DATE SUBMITTED	DESCRIPTION
2	4-29-2010 REVISED PER APPROVAL COMMENTS
1	4-28-2010 REVISED PER APPROVAL COMMENTS
0	3-22-2010 SUBMITTED FOR APPROVAL

PROJECT	REVISIONS
MERRIMACK SHEET METAL	03
119 HALL STREET	
CONCORD NH 03301	
Tel. 603.224.7766	
Fax 603.224.7925

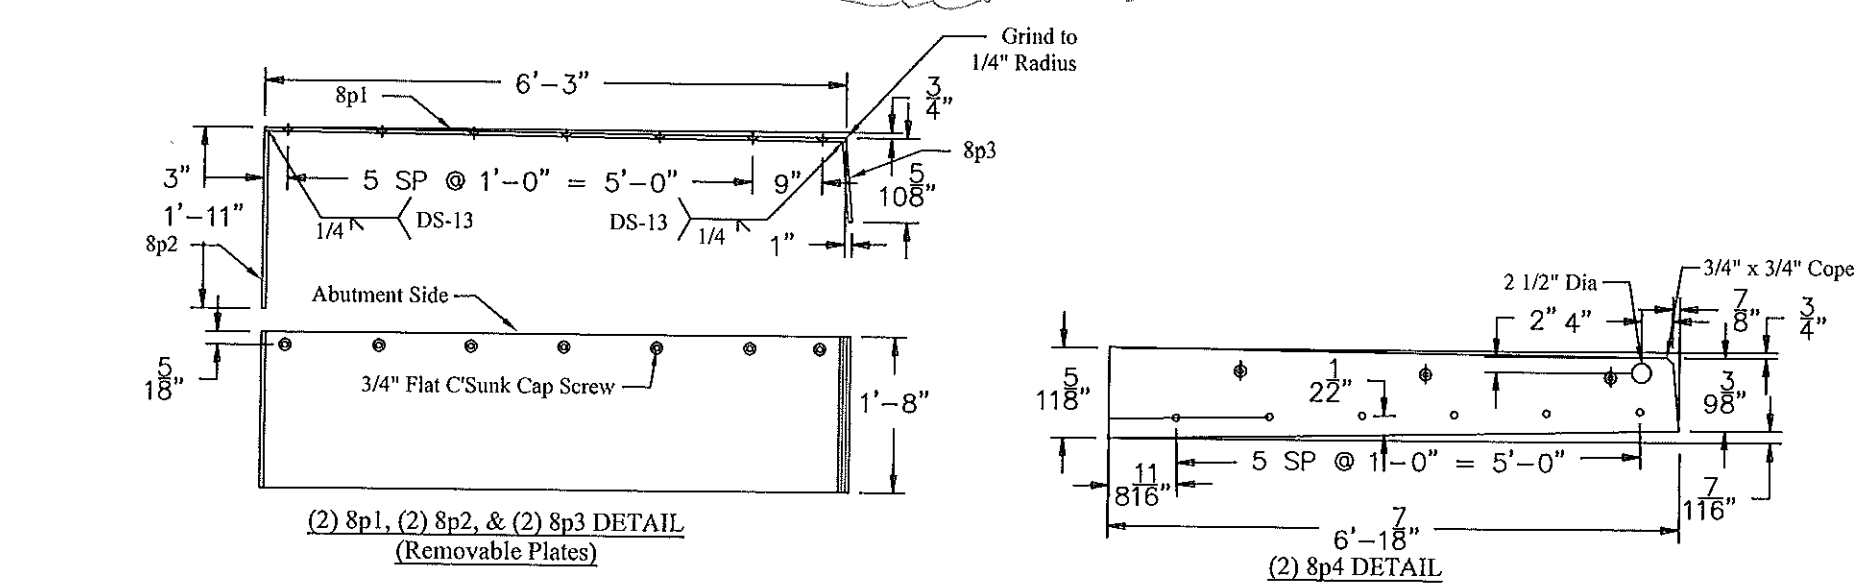
Revised.

I believe per Drawings, Removable Plates are 1/2" thickness to provide 1/8" gap on Abutment side
(Please let me know if this is incorrect)
